SAN ANTONIO WATER SYSTEM
SUNSET GROUND STORAGE TANK
PAINTING AND REHABILITATION PROJECT
SAWS Job No. 11-0108
SAWS Solicitation No. B-13-065-DD

ADDENDUM NO. 1
October 7, 2013

HANDRAIL AND ACCESS HATCH DETAIL B
 SCALE: NTS C7

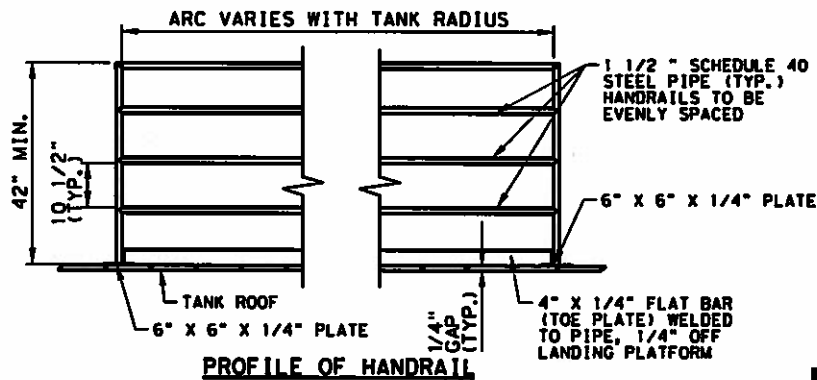
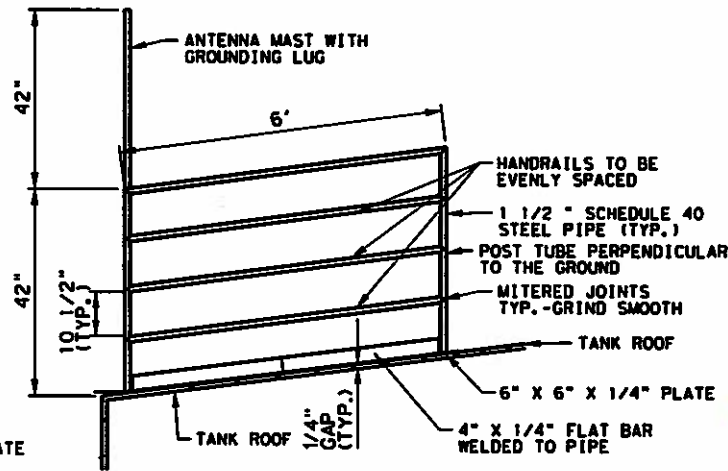
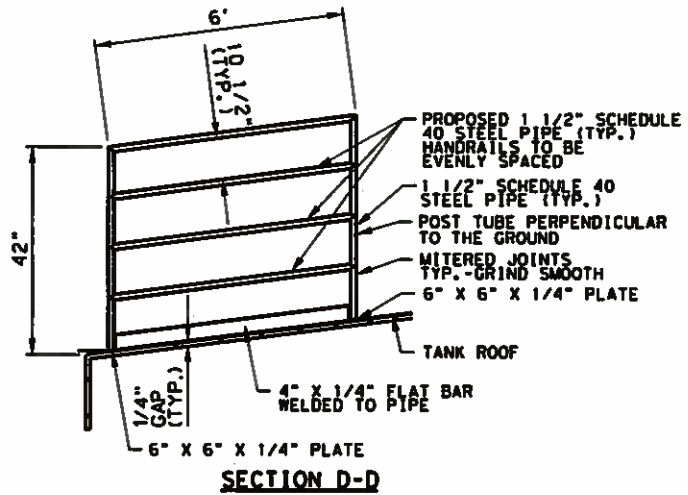
1. REPLACE Detail B: Handrail and Access Hatch Detail on Sheet C7 with the attached drawing on Sheet 1.
2. REPLACE Section C-C and D-D of Detail B: Handrail for Roof Hatch at Weir Box Detail on Sheet C9 with the attached drawing on Sheet 2.
3. REPLACE Detail D: Outlet Pipe Safety Railings Detail on Sheet C10 with the attached drawing on Sheet 2.

1. ADJUST LOCATION BASED ON FIELD MEASUREMENTS.
2. PROVIDE ADDITIONAL HANDRAIL AT HATCH OPENING.
